Preliminary Consultation
MONTGOMERY COUNTY HISTORIC PRESERVATION COMMISSION
STAFF REPORT

Address:	7017 Sycamore Ave., Takoma Park	Meeting Date:	7/10/2024
Resource:	Contributing Resource Takoma Park Historic District	Report Date:	7/3/2024
Applicant:	Rolf Reichle & Amy Schwenkmeyer Brian McCarthy, Architect	Public Notice:	6/26/2024
Review:	Preliminary Consultation	Staff:	Dan Bruechert
Proposal:	Alterations to front porch, partial demolition and new construction of rear deck

Figure 2: Existing (left) and proposed (right) front porch configuration.

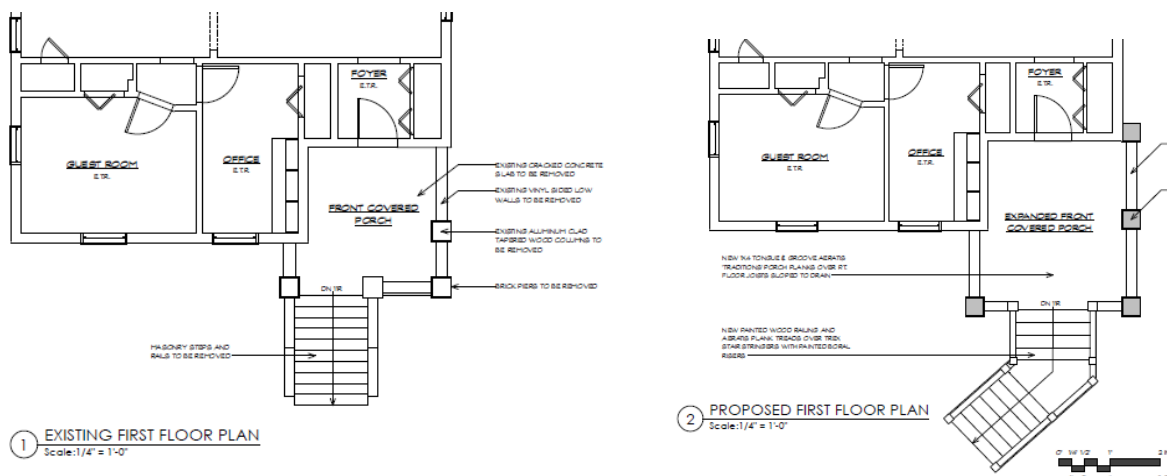
Staff has outstanding questions as to the compatibility of the run of the new front stairs (see *Figures 2 and 3*, below). Because of the location of the existing concrete path and the slope of the lot, the applicant proposes to have the stairs turn approximately 45° (forty-five degrees) to the left (west). This turn in the stairs will allow the new stairs to satisfy the code and align with the existing front walk. However, Staff finds that this type of stair run is not typical of historic Craftsman architecture and obscures much of the front porch. Staff requests feedback from the HPC regarding the appropriateness of this design.

Staff's initial alternative is to have the stairs exit the porch from the left, along the house's front wall, and make a 90° (ninety-degree) turn towards the street (south). The stairs could either have a brick cheek wall or could have a lattice between the posts. Staff recognizes this would cover an existing basement window however, the basement floor plan does not indicate that access to this window is required to satisfy egress requirements.

- The appropriateness of the proposed wood railing and baluster on the proposed front porch;
- The appropriateness of the stair run proposed and;
 - The desirability of Staff's alternative;
- Does the HPC concur with Staff's finding that the proposed Aeratis porch flooring is appropriate?
- Does the HPC find that a substitute material is appropriate for the columns and stair risers?
- Does the HPC concur with Staff's finding that the proposed Trex fascia is inappropriate to cover the stair stringers?

Figure 3: Existing (left) and proposed (right) front elevation showing the existing and proposed front stairs.

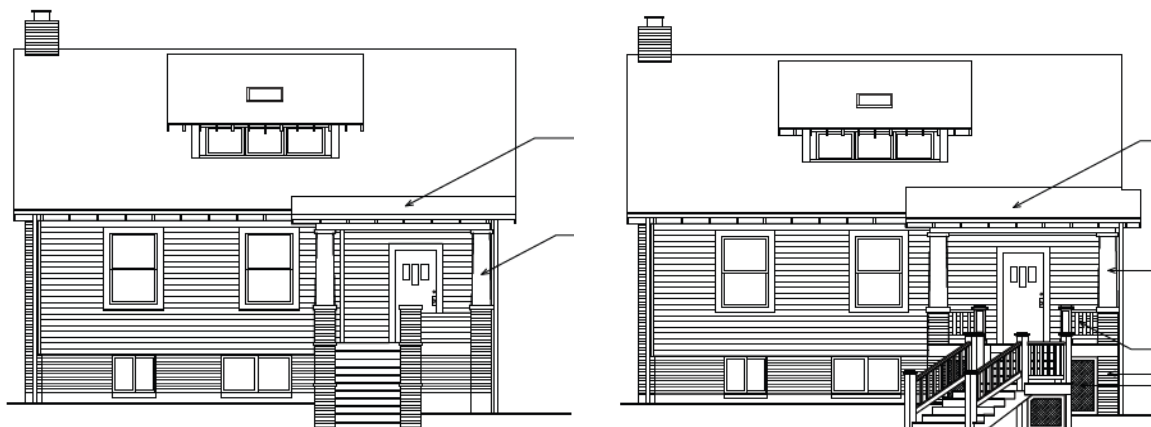
The existing front stairs are too steep to comply with the existing building code. Additionally, the brick used to construct the cheek walls does not match the brick used on the foundation and column bases, which suggests to Staff that these stairs are not historic. The applicant proposes to demolish the existing stairs and the brick cheek walls. Staff finds the demolition of these elements will not significantly alter the character of the house or the surrounding district and supports their removal under 24A-8(b)(4) and (d).
